ADDENDUM NUMBER ONE.

DATE: AUGUST 9, 2006

BOONE COUNTY COURTHOUSE REMODEL COLUMBIA, MISSOURI

PROJECT NUMBER 14523-06

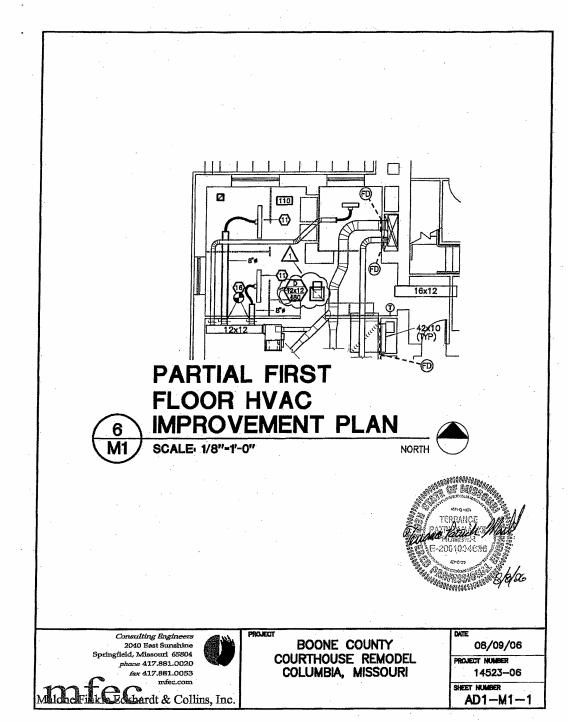
- Refer to revised sheet E1, "Partial First Floor Electrical Demolition
 - At the existing restroom and breakroom, all receptacles and outlets to remain unchanged. The keynotes shall be changed from #10 to #19 as shown on attached sheet AD1-E1-1.
 - Currently there is not an existing receptacle on the south wall of the south office. This has been removed on the attached sheet AD1-E1-1.
- Refer to revised sheet E1, "Partial First Floor Electrical Demolition

AD1-E1-2

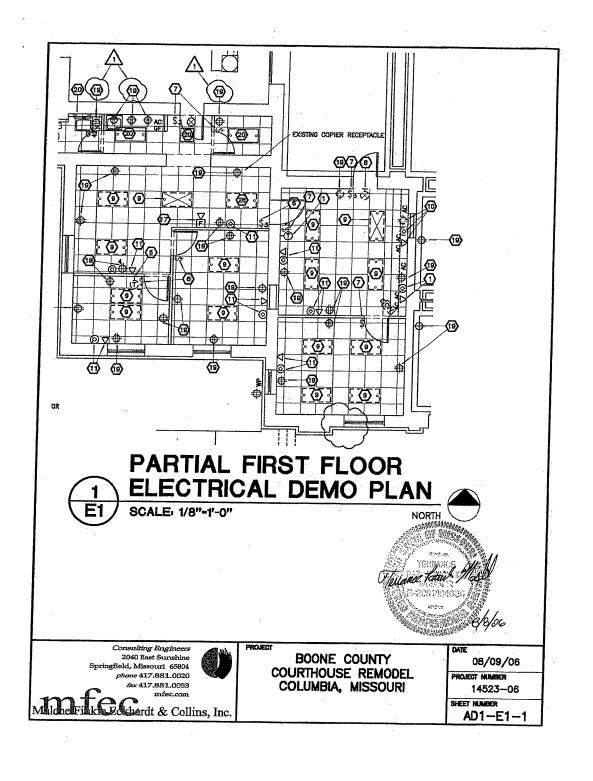
- The existing receptacle and data outlet on the north wall shall be relocated to the opposite side of the column as shown on attached sheet AD1-E1-2. Keep circuit continuity. Patch wall at existing outlet locations.
- Refer to revised sheet E1, "Partial First Floor Electrical
 - Provide new data/telephone outlet adjacent to floor copier in room 107 as shown on attached sheet AD1-E1-3.
 Provide new data/telephone outlet at reception desk in room 102 as shown on attached sheet AD1-E1-3.

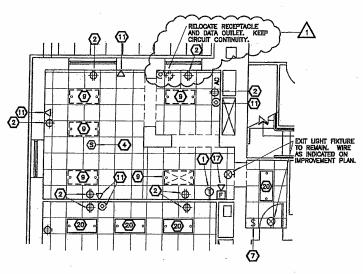
- Provide new receptacle and data/telephone outlet on south wall of office 103 as shown on attached sheet AD1-E1-3. Connect circuit to nearest receptacle in room.
- Refer to revised sheet E1, "Partlal First Floor Electrical Improvement Plan, 6/E1":
 - Relocate existing receptacle and data/telephone outlet to opposite side of column in room 110 as shown on attached sheet AD1-E1-4. Keep circuit continuity. Relocate new floor copier receptacle from room 110 to adjacent room on north walf as shown on attached sheet AD1-E1-4. Provide data outlet adjacent to receptacle. Provide new receptacle and data/telephone outlet on south walf of office 110 adjacent to cubicle as shown on attached sheet AD1-E1-4. Connect circuit to adjacent receptacle.
